# Standard Support and Environmental Impact Statement. Volume II: Promulgated Standards of Performance for Stationary Gas Turbines

EPA-450/2-77-017b
September 1979

15. SUPPLEMENTARY NOTES Volume I discussed the proposed standards and the resulting environmental and economic effects. Volume II contains a summary of public comments, EPA responses and a discussion of differences between the proposed and promulgated standards.

Figure 2-1. Controlled $NO_x$ emission levels vs fuel-bound nitrogen level

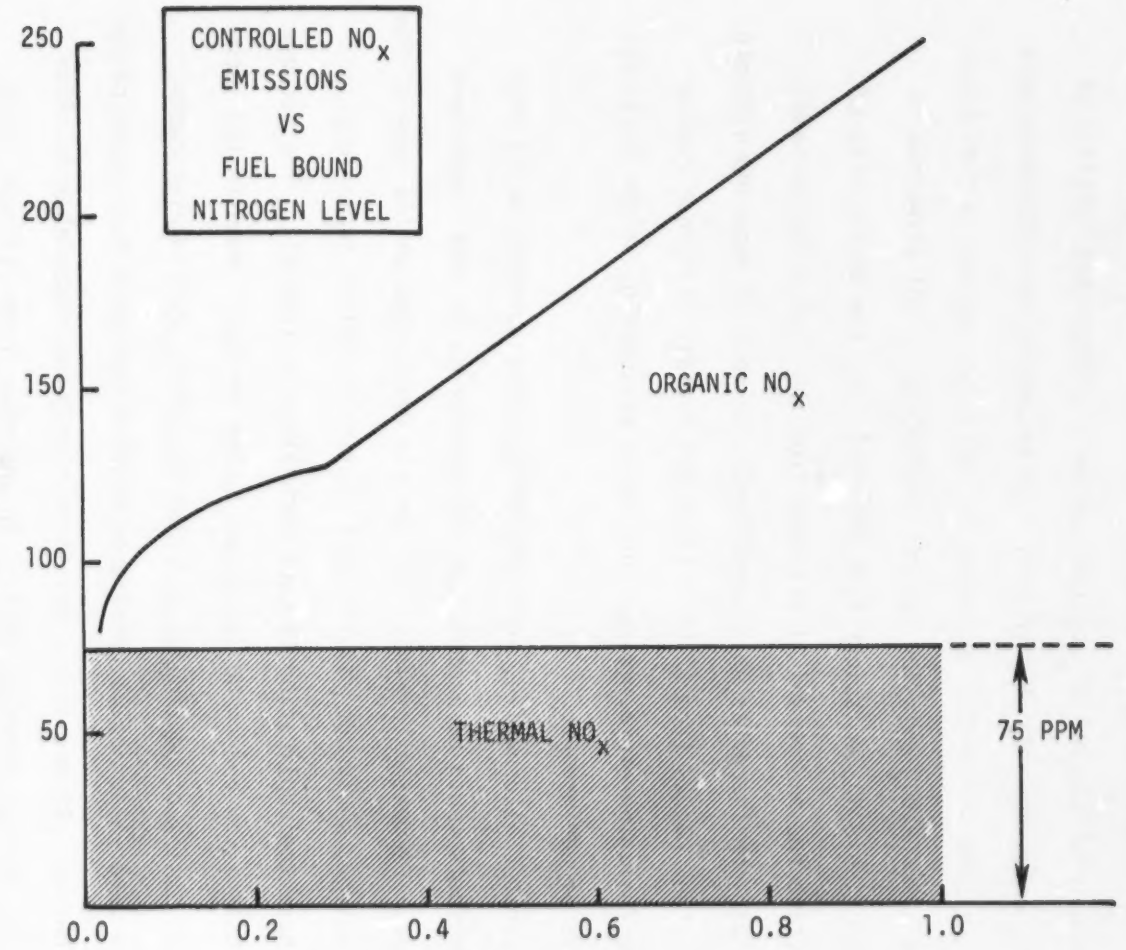
As fuel-bound nitrogen increases, the organic $NO_x$ emissions from a gas turbine with thermal $NO_x$ control become a predominant fraction of total $NO_x$ emissions (See Figure 2-1). Consequently, the standards must address in some manner the increased $NO_x$ emissions caused by fuel-bound nitrogen. Since $NO_x$ emission control technology is not effective in reducing organic $NO_x$ emissions from gas turbines, the possibility of basing standards on removal of nitrogen from the fuel prior to combustion was considered as an alternative. The cost of removing nitrogen from the fuel ranges from $2.00 - $3.00 per barrel. Nitrogen removal from the fuel, therefore, is not considered reasonable, as the basis for standards of performance.

Two other alternatives were considered. Gas turbines using high nitrogen fuels could be exempt from the standards, as some commenters requested. Exempting turbines from the standard based on the type of fuel used, however, would not require best available control technology in cases where the application of such technology is feasible. The purpose of the NSPS is to reduce $NO_x$ emissions using the best demonstrated technological system of continuous emission reduction, considering costs.

The other alternative considered would establish a fuel-bound nitrogen allowance. Beyond some point it is simply not reasonable to allow combustion of high nitrogen fuels. In addition, high nitrogen fuels, including shale oil and coal-derived fuels, can be used in other combustion devices in which control of organic $NO_x$ emissions is possible. In fact, utility boilers can achieve 30 - 50 percent reduction in organic $NO_x$ emissions. Greater reduction of nationwide $NO_x$ emissions could be achieved
